PLANT NAME: H. B. Robinson Unit No. 2

H. B. ROBINSON UNIT NO. 2
DOCKET NO. 50-261
LICENSE NO. DPR-23

Your letter of June 5, 1973 requested additional information to assist you in your evaluation of uncontrolled releases of radioactive liquids as reported by our letters of April 24, 1973, and May 1, 1973. The additional information requested was included as Attachment A to your letter and the following is submitted in direct response to that request.

FIGURE 1

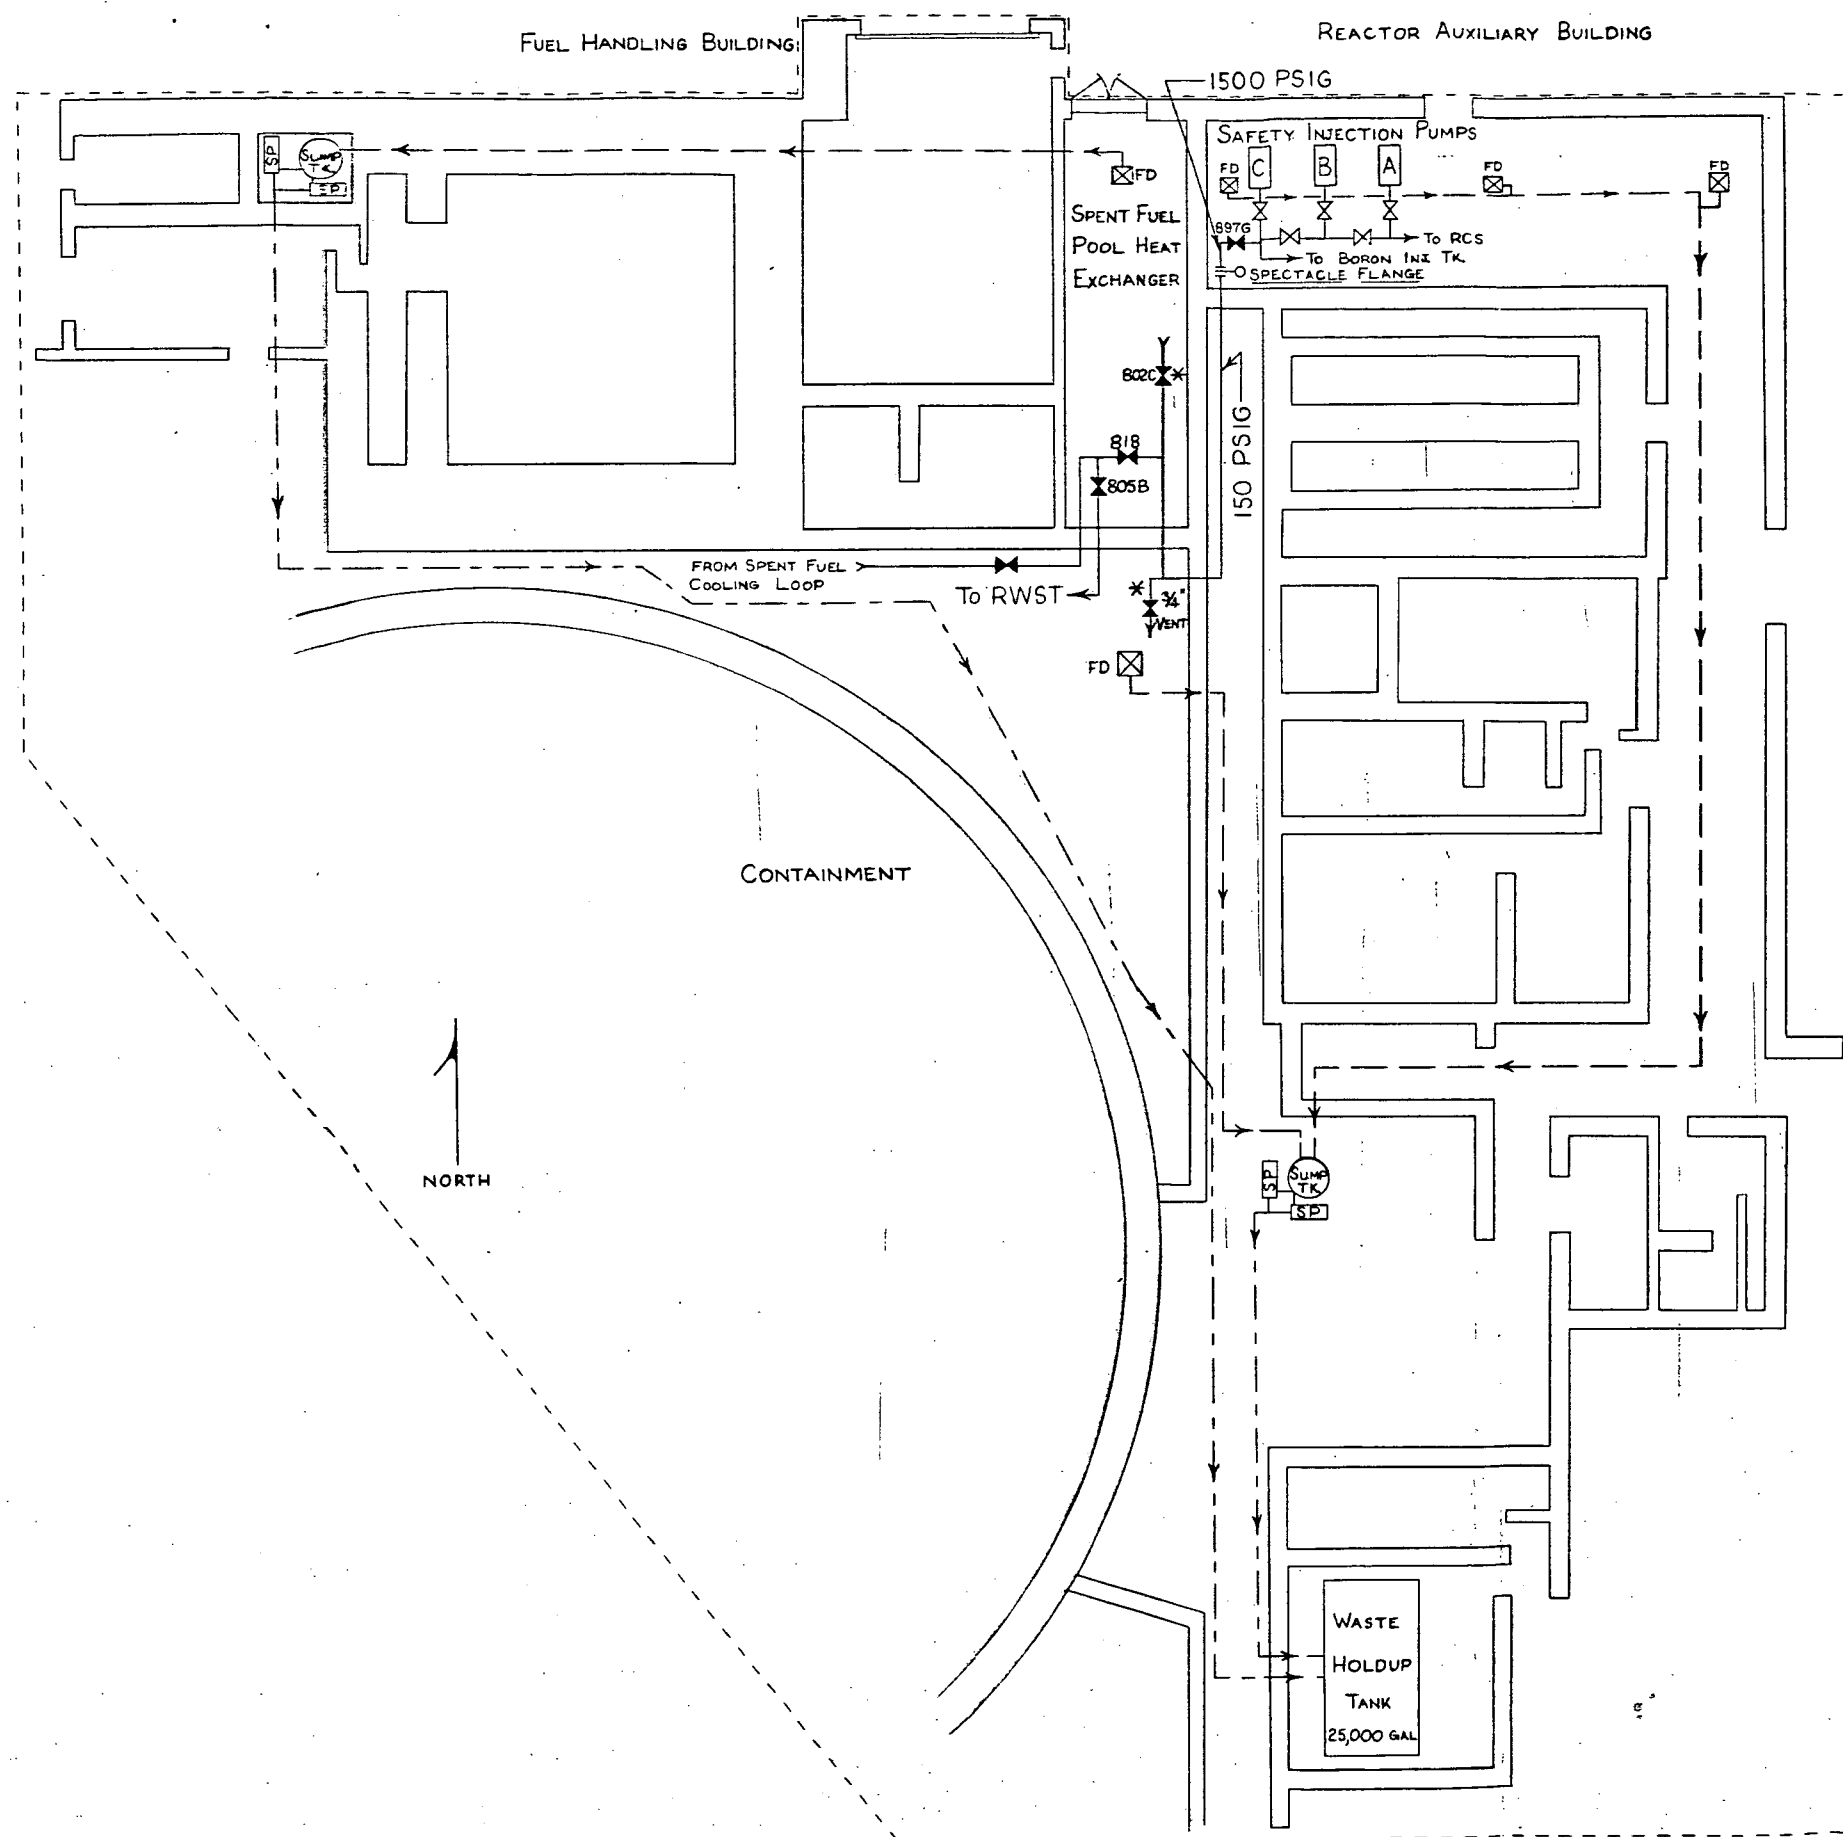
Item 1. For the April 10 abnormal occurrence, provide a schematic diagram of the system in which the leak occurred and of related systems. Identify on the schematic diagram: design pressures, the valve which leaked, the safety injection pump which was running, the spectacle flange and any other flanges of interest. Describe the need for: interconnection of the systems involved, the spectacle flange and any similar or related flanges, and pressure relief valves and appropriate routing of their effluents.

Item 2. For spaces containing the systems above, describe in detail: their drainage, the location and volume of sumps, sump level sensors and alarms, and the divide between areas which drain to onsite and offsite sumps.

Response: Figure 1 gives a schematic representation of the system in question. As shown, the design pressure of the safety injection system is 1500 psig up to the spectacle flange with the design pressure of the spent fuel clean-up system being 150 psig. Safety Injection Pump A was running at the time of the incident with leakage occurring at valve 802C and the 3/4 inch vent valve.

The divide between areas which drain to onsite and offsite sumps is shown on Figure 1.

FIGURE 3

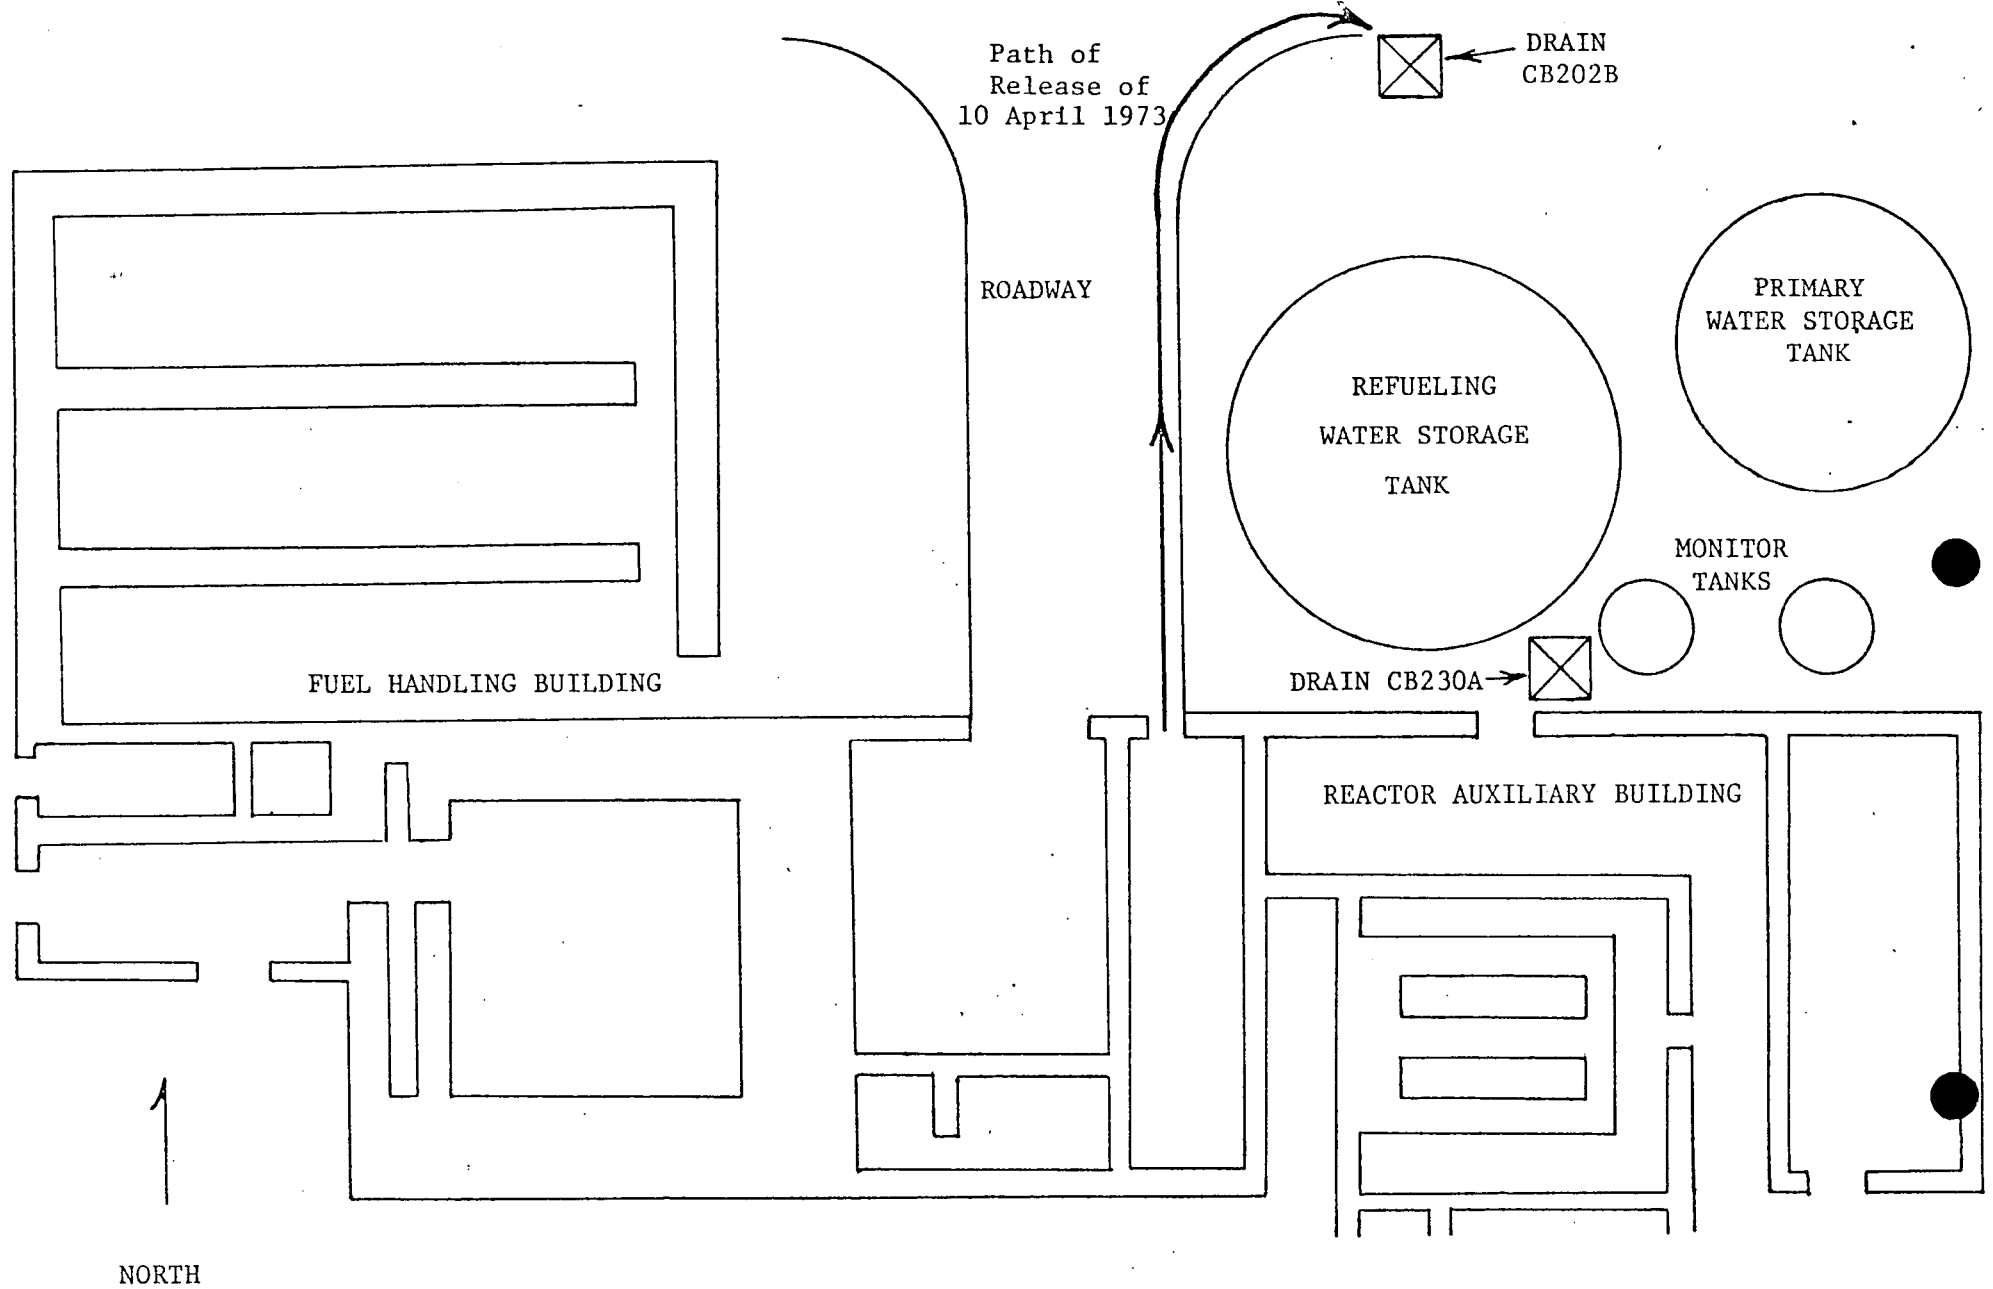
Item 3. For the abnormal occurrences of April 10 and 23, identify in detail the path of the effluent from the source of leakage to Black Creek. Indicate the points at which the effluent crossed restricted area boundaries, the fence line, and the site boundary. Identify the points at which dilution occurred and how the amount of dilution was estimated. Estimate the fraction of MPC (10 CFR Part 20, Appendix B, Table II, Column 2) at each point. Provide the results of soil samples taken from the effluent path.

Response: The April 10 incident occurred in the spent fuel pool heat exchanger area. Water spilled into this area, overflowed a concrete sill at the door on the north side of the area and flowed into drain CB202B (Figure 2). Overflow from the refueling water storage tank on April 23 flowed directly into drain CB230A. From there the water flowed through drain piping to drain CB202B, which is the point where the water from the April 10 incident entered the drainage system. In both incidents the leakage was directed underground to the drainage ditch south of the facility passing drains CB203, CB204, CB7, CB8, CB9, CB14, CB15 and CB226.

Figure 3 identifies the point at which the drain pipe enters the drainage ditch. From this point flow was down the drainage ditch approximately 300 feet in a southerly direction and then east for some 100 feet. At this point flow was again underground passing beneath the plant access road and picnic area. The flow then emerged east of the picnic area and continued along the drainage ditch almost due east for about 600 feet and into Black Creek (Figure 4).

As shown in Figure 3, the immediate area surrounding the plant is enclosed with a fence for access control purposes. The releases in question crossed this fenced area underground prior to flowing into the drainage ditch.
